**PZ&B Staff Combination Memorandum: Town Council and Landmarks Preservation Commission**

**SUBJECT:** COA-23-031 (ZON-23-089) 223 COLONIAL LN (COMBO)

**MEETING:** OCTOBER 18, 2023 LPC  
NOVEMBER 15, 2023 TC

The applicant has submitted revised plans, entitled "WASSERMAN RESIDENCE", as prepared by **SKA ARCHITECT + PLANNER**, dated September 12, 2023.

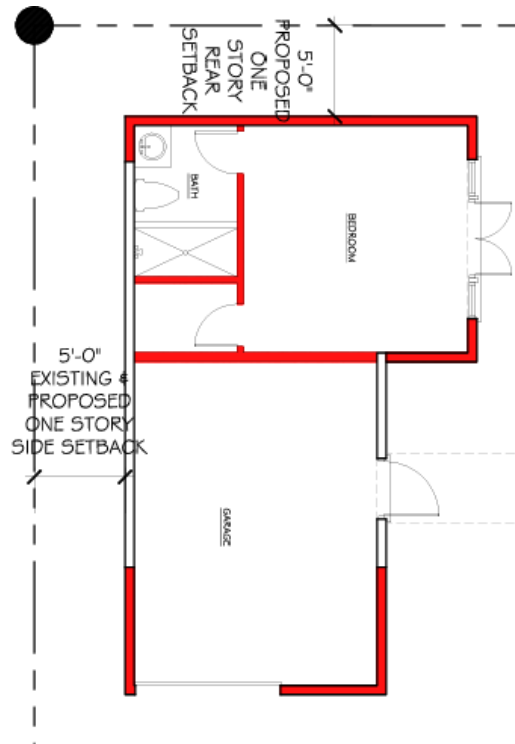
As it pertains to Variance 1, a variance for a side yard setback of 5' in lieu of the 12.5' required for an addition to an enclosed accessory structure, the applicant is seeking to maintain and continue a nonconforming west side yard setback as part of the renovation and addition to the existing detached garage structure.

WEST ELEVATION

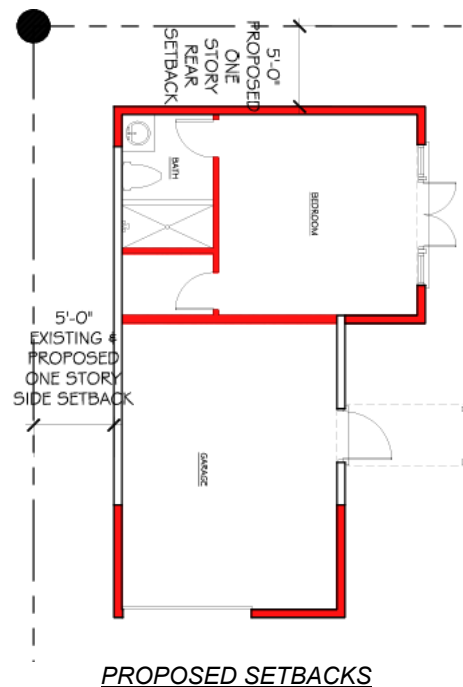
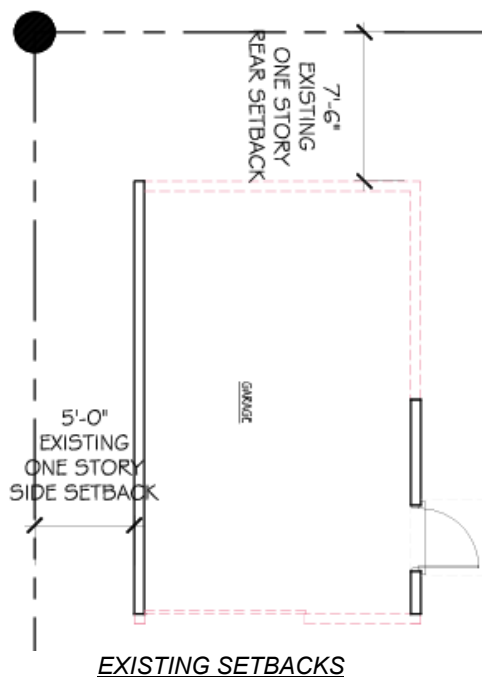
As it pertains to Variance 2, a variance for a rear yard setback of 5' in lieu of 7.5' existing and 10' required for an addition to an enclosed accessory structure, the applicant is proposing to encroach further into required rear yard setback as part of the garage renovation and addition.
